II. PROJECT DESCRIPTION AND SUMMARY OF ISSUES

A. PROJECT DESCRIPTION

This project plan is an application for the optional method of development in the RMX -3C zone. Montrose Crossing Inc. filed the complete application on December 8, 1994 (see Appendix).

Figure 1 - Proposed Nebel Street right-of-way with a temporary narrower street configuration.

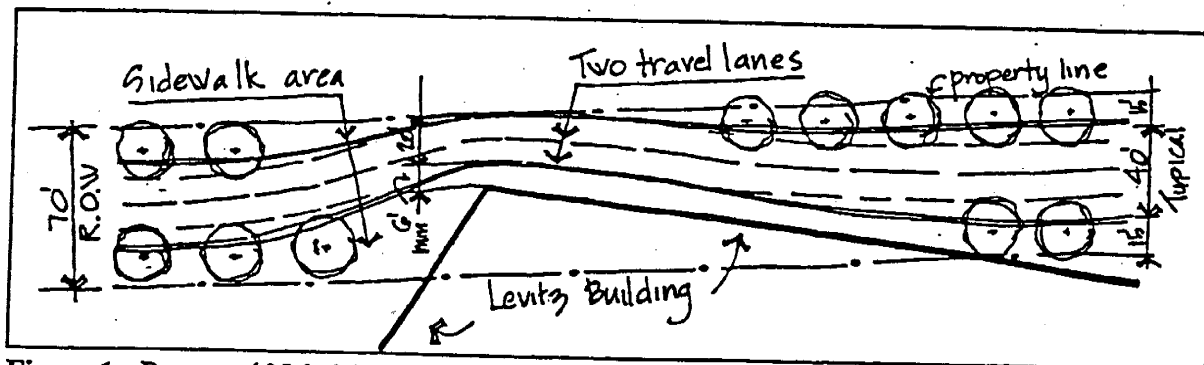
Nebel Street will be dedicated by the applicant at the time it is 100% funded in the CIP. The adjacent property, which is owned by Giant and leased to B.F. Saul, would also dedicate the right of way but would be severely impacted by that dedication. In order to facilitate the provision of Nebel Street, agreements would be necessary for the provision of a portion of the B.F. Saul parking on the subject site. Condition #4 calls for the two parties to enter into an agreement for the provision of the required spaces. This condition also reflects the fact that a portion of the Levitz building, which has a 39 year lease, is within the proposed right-of way. If dedication occurs prior to the expiration of the lease, Levitz's approval would be required. A temporary narrower street configuration along a short portion will be required to avoid modifications to the building (see figure 1)

Figure 2 - The open space diagram

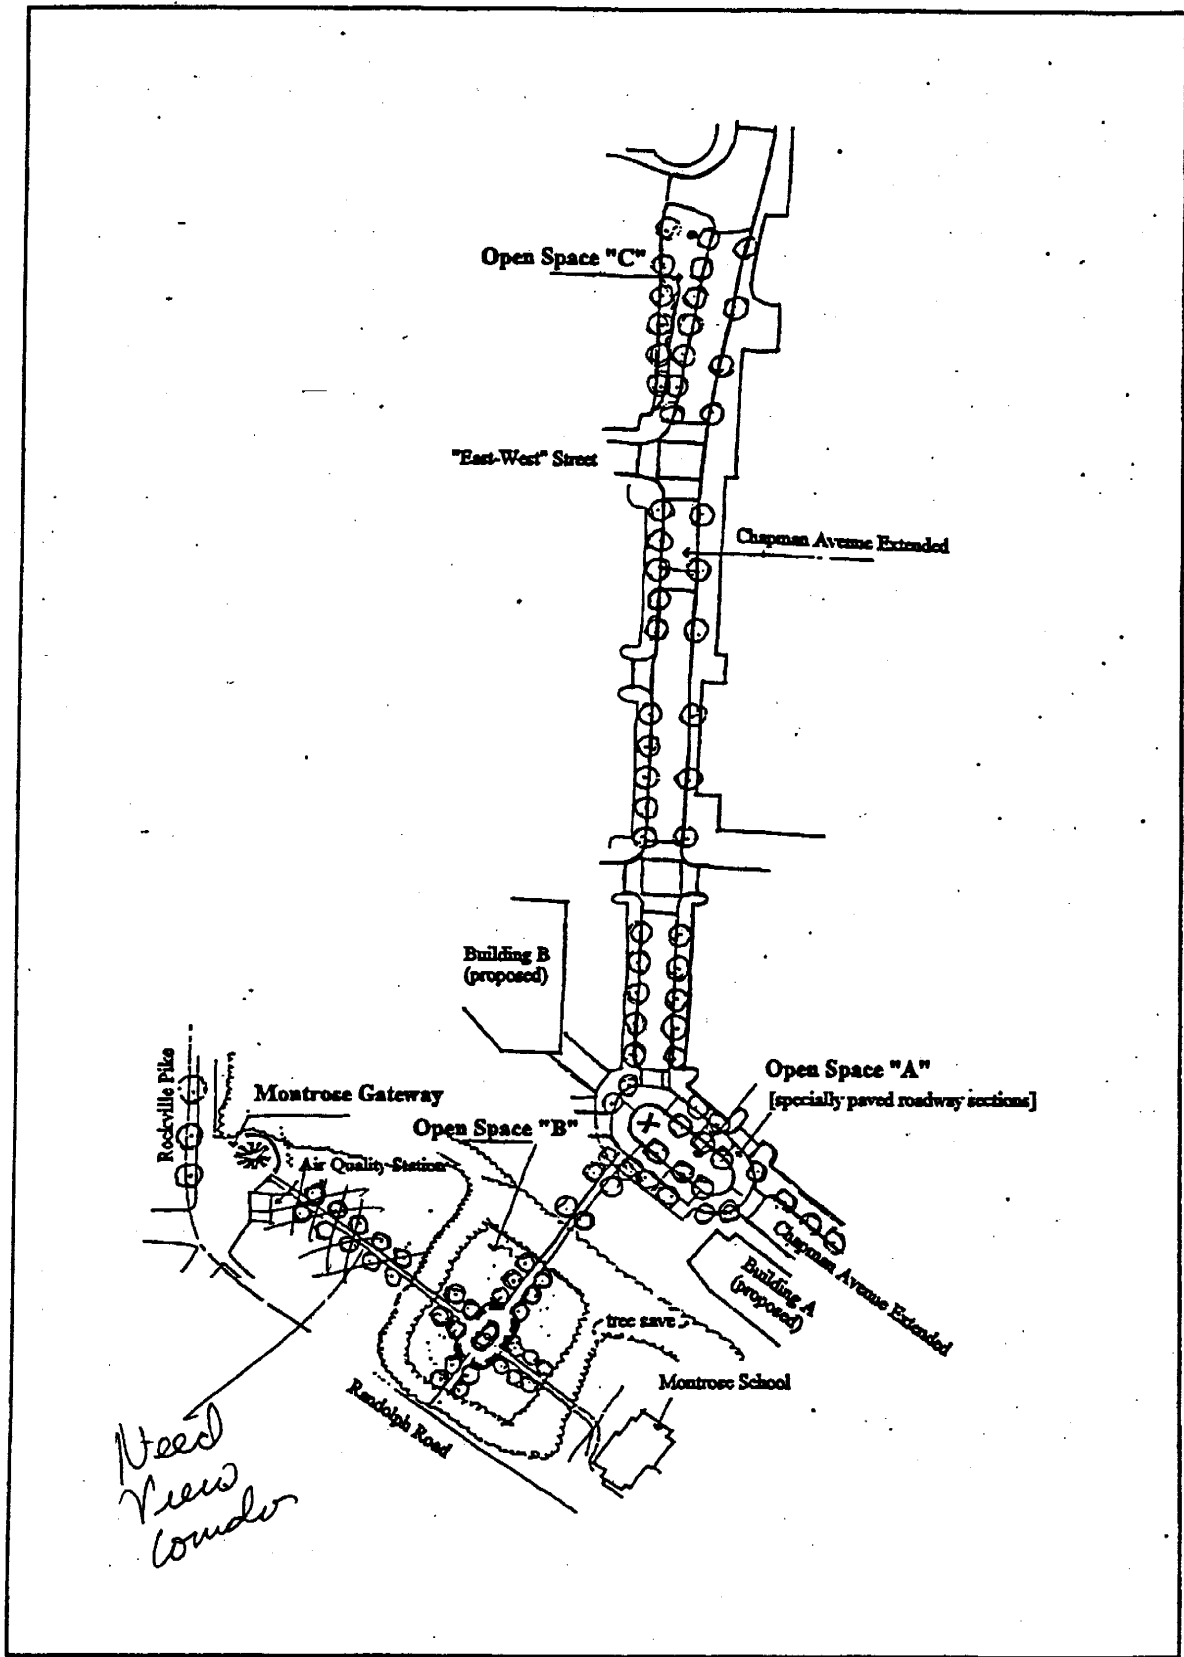
Open Space A, adjacent to building A is an oval green area of approximately 4,400 sf which also serves as a traffic circle. The surrounding roadway should be specially paved so it is perceived as part of the open space and is better linked to the surrounding sidewalks and building. This open space should also be linked to building B (see condition 12).

Open space B, is located to the west of the Historic Montrose School, within the SHA right-of-way. It is partially covered by dense woods. The open area should be improved with seating and a significant lawn area. It should also include tree lined paths to create the desired North-South and East-West axes, which would link the open spaces along Randolph Road to the development.(see condition 13)

Open Space C is a triangular green area, measuring approximately 4,000 sf, adjacent to the Chapman Avenue sidewalk and south of building C. The proposed special paving within the surrounding roadway will link this space to both buildings C and D, which would activate it. This space should include a garden and seating.(see condition 14).

The Montrose Gateway, at the corner of Rockville Pike and Randolph Road, is proposed to have an impressive sculptural feature to anchor the gateway. The staff condition also calls for visual improvement to the adjacent air quality station as well as a pedestrian axis to the Montrose School (see condition 15)
